SUBJECT: Coastside Design Review  
Avenue Alhambra, El Granada  
APN 047-043-240; County File No. PLN 2016-00085

At its meeting of January 12, 2017, the San Mateo County Coastside Design Review Committee (CDRC) considered your application for a design review permit to allow construction of a new 3,067 sq. ft. two-story single-family residence (including a 587 sq. ft. attached two-car garage) on a 6,485 sq. ft. legal parcel (Certificate of Compliance recorded on November 12, 2015). The project involves minor grading and no tree removal.

REAR ELEVATION VIEW-EAST LOOKING WEST

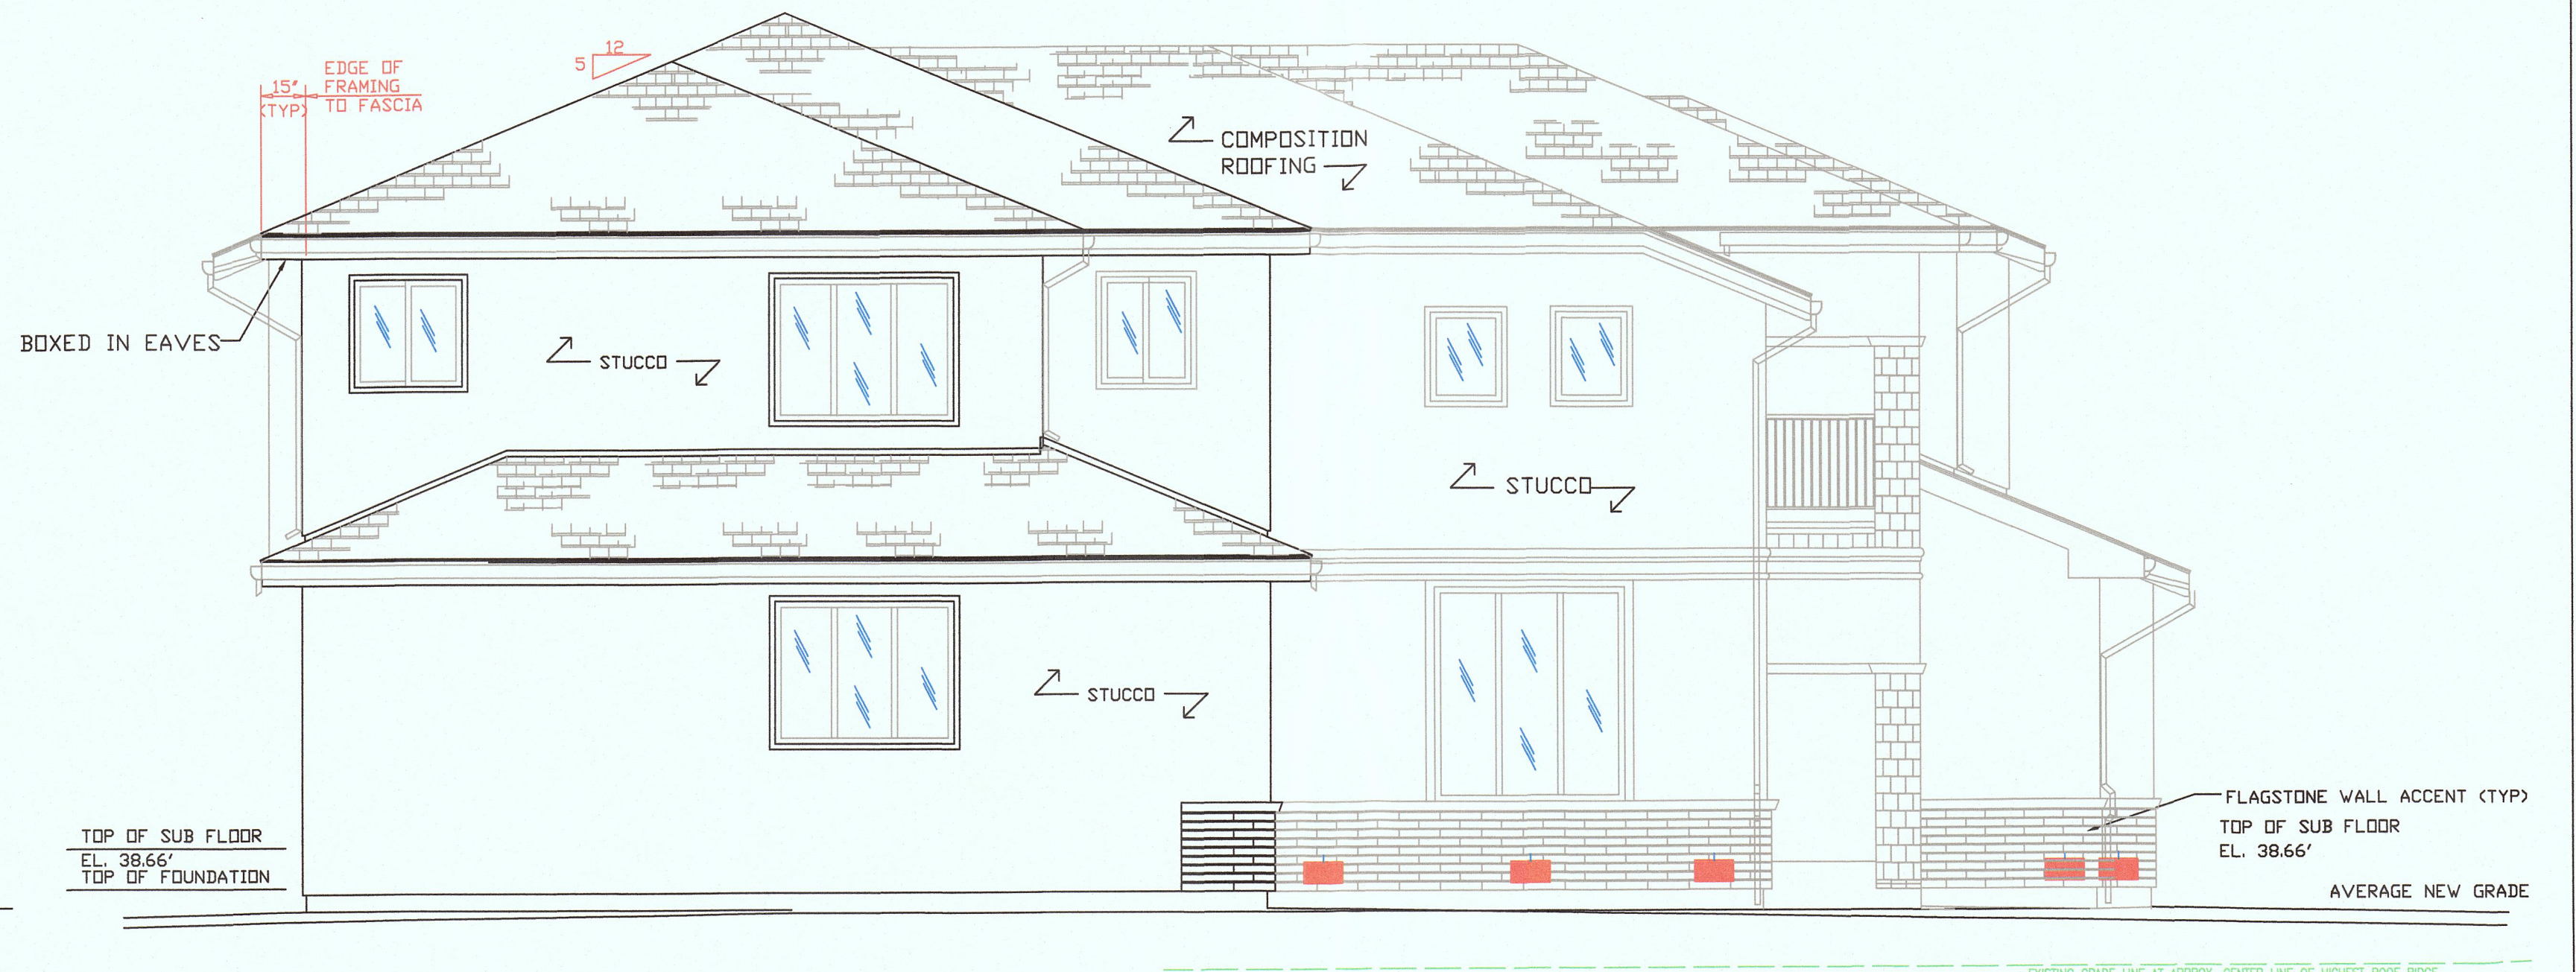
- a. Section 6565.20(D). ELEMENTS OF DESIGN; 1. Building Mass, Shape and Scale; e. Wall Articulation. Standard (2). Provide projecting or recessing architectural details and changes in building materials or colors to visually break up building walls in the Rear/East and Side/South elevations. This standard also needs to be applied to the enclosed decks in the project design to reduce their apparent mass.

FRONT ELEVATION VIEW-WEST LOOKING EAST  
1/4"=1'-0"

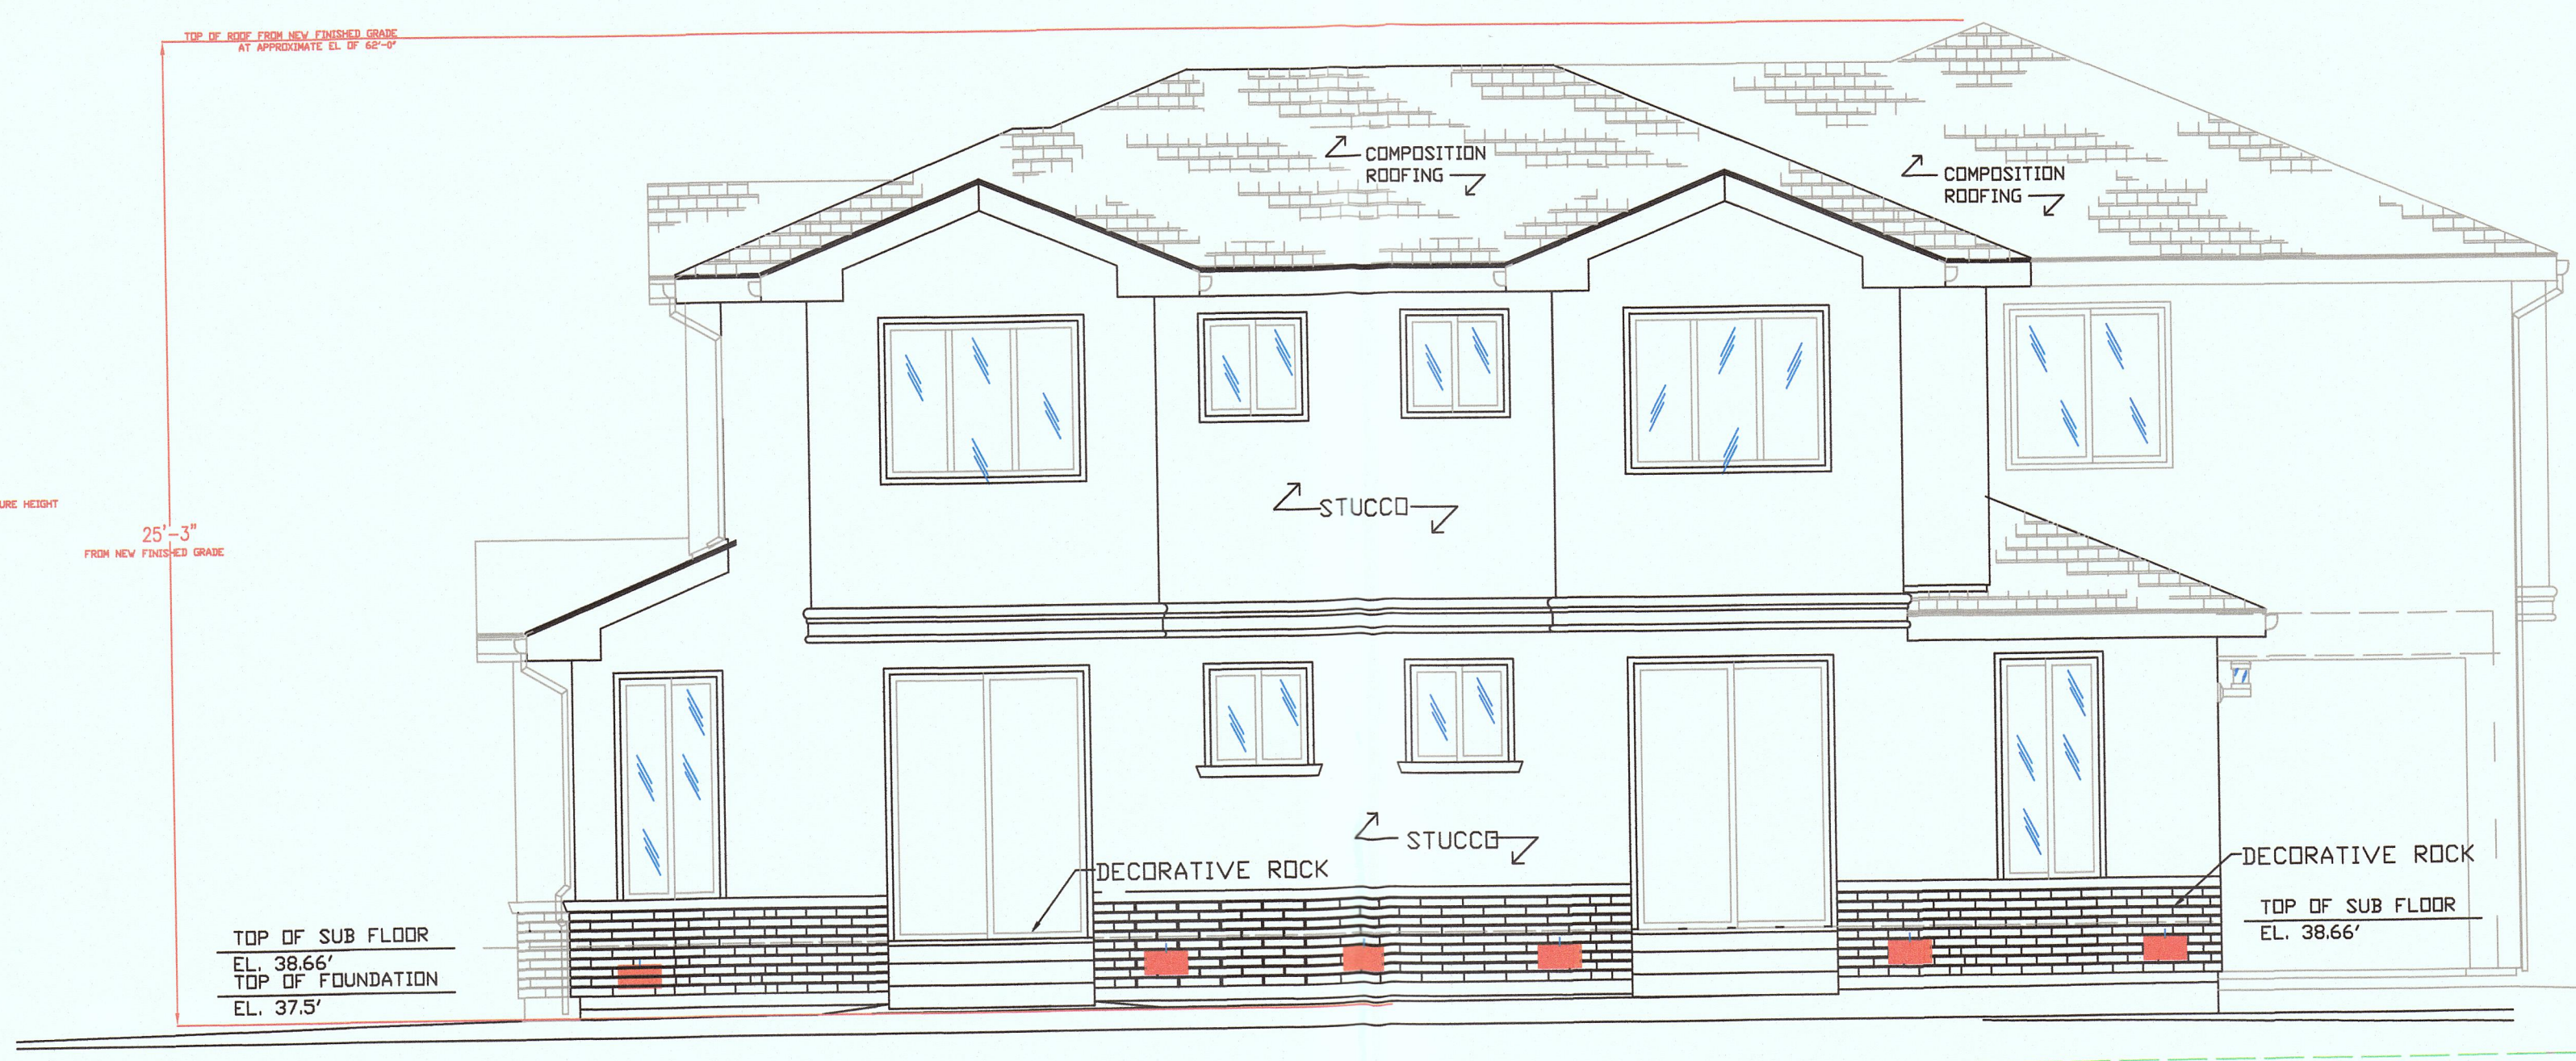
- b. Section 6565.20(D). ELEMENTS OF DESIGN; 2. Architectural Styles and Features; b. Openings. Standard (1). Select windows for the Front elevation that are compatible with the other windows and features of the house (See the picture on page 15 of "Standards for Design for One-Family and Two-Family Residential Development in the Midcoast" manual).

- c. Section 6565.20(D). ELEMENTS OF DESIGN; 2. Architectural Styles and Features; c. Entries. Standards (1) and (2). Design the front entry to be on a scale compatible with other features of the house (1) and so that it is similar in size and proportion to other homes in the neighborhood (2) (See the picture on page 16 of "Standards for Design for One-Family and Two-Family Residential Development in the Midcoast" manual).
